**Subject: Notification of Class 1 Permit Modification Facility Description Updates for the Technical Area 63 Transuranic Waste Facility Container Storage Unit, Los Alamos National Laboratory Hazardous Waste Facility Permit, EPA I.D. #NM0890010515 (NA/LA)**

**Class 1 Permit Modification  
Facility Description Updates for the  
Technical Area 63 Transuranic Waste Facility  
Container Storage Unit,  
Los Alamos National Laboratory  
Hazardous Waste Facility Permit**

**EPC-DO: 17-196**

**FIGURE 55.**

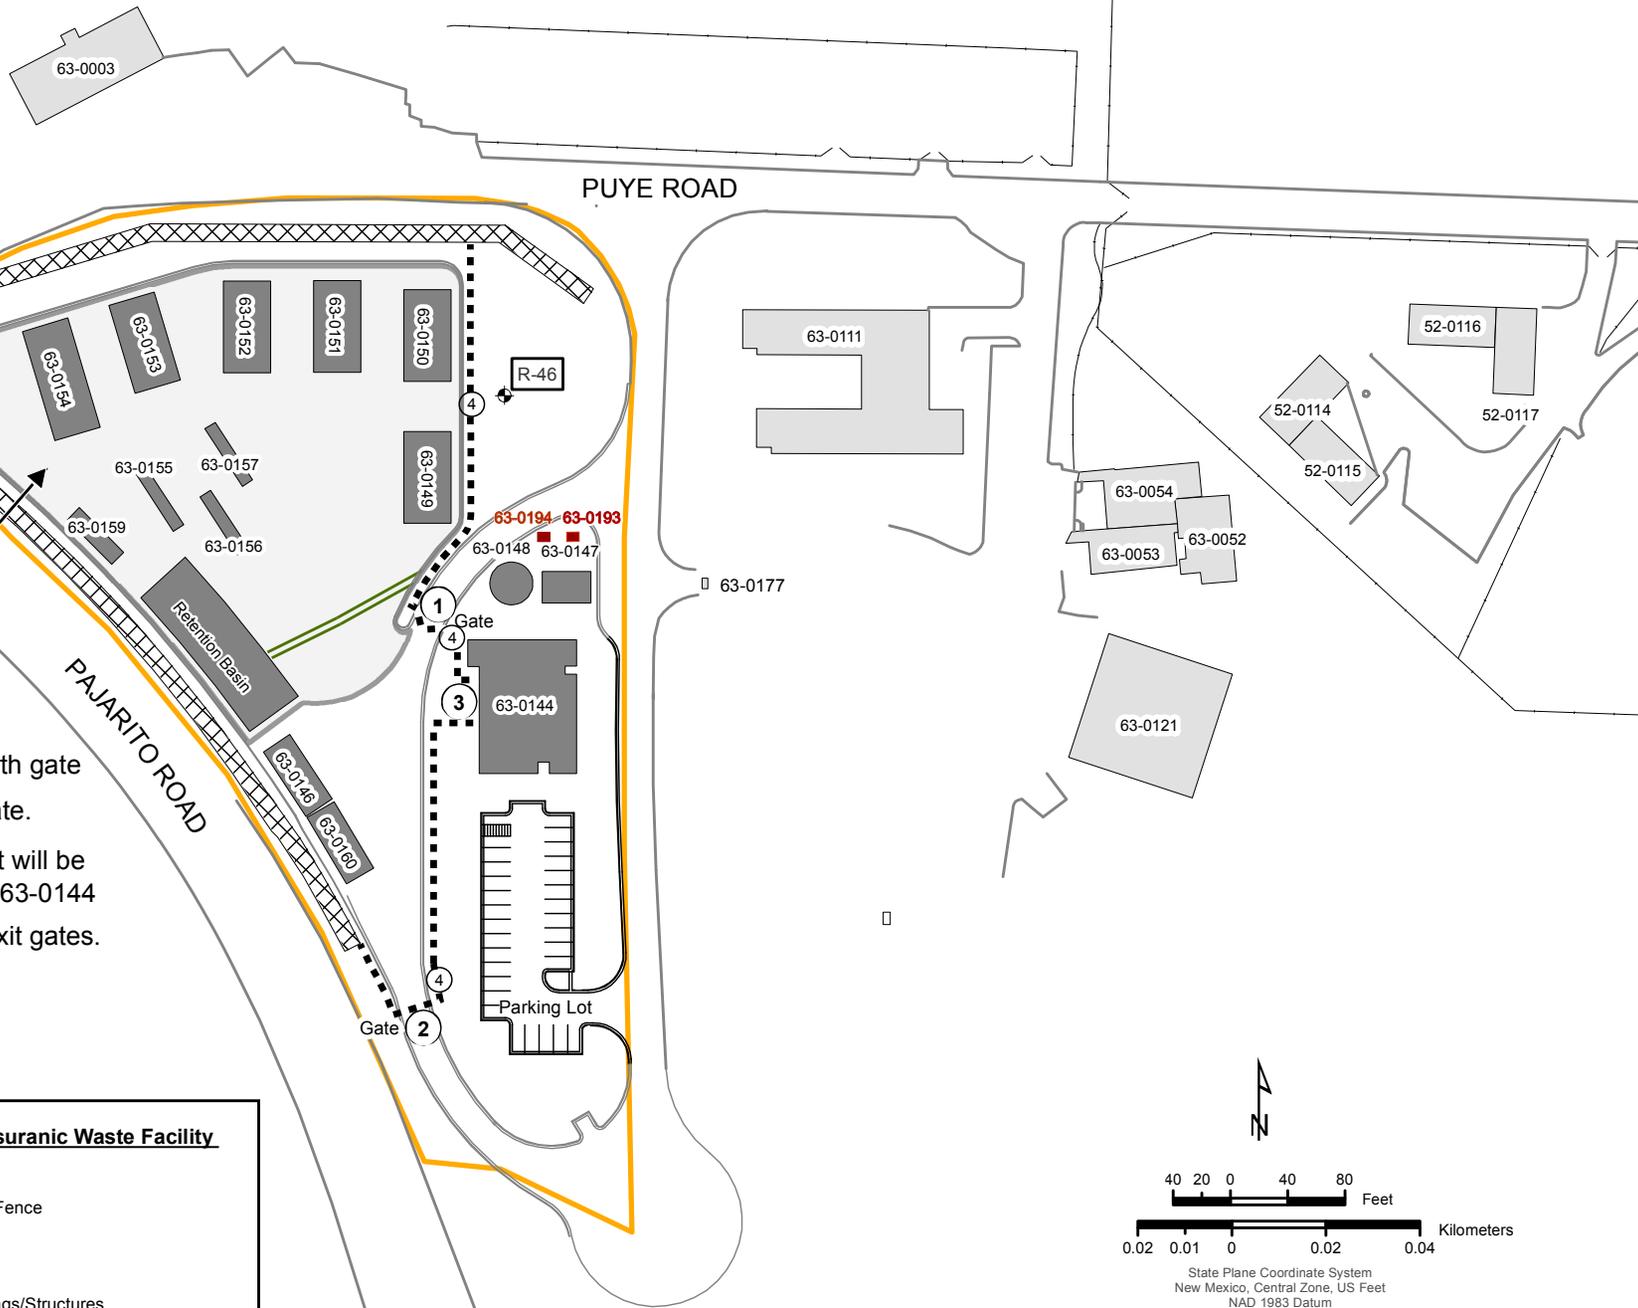
Permit Section A.6.6, *Other Project Structures*, Permit Figure 55, *Technical Area (TA) 63 Transuranic Waste Facility*, and Permit Figure G.27-1, *Transuranic Waste Facility Soil Sampling Grid*, have been revised to include descriptions and locations of two equipment structures associated with the TA-63 TWF. The two concrete structures are located north of TA-63-0144 (the Operations Support Building), are not within the permitted storage unit and are not used to manage hazardous waste containers. The structures are concrete enclosures for two seismic power cutoff systems. The seismic systems are control relays used to shut off power to the TA-63 TWF waste storage buildings and characterization trailers in the event of an earthquake to prevent potential electrical fires involving waste containers. A sentence has been added to Permit Section A.6.6 stating that two seismic power cutoff system enclosures are present north of the Operations Support Building. Figure 55 has been revised to provide the location of the concrete structures. Figure G.27-1 has been revised to show the location of the concrete structures and also to provide other changes updating the depiction of the surrounding area such as removed buildings, parking lots, and the facility vehicle barrier. Attachment 4 includes these revisions.
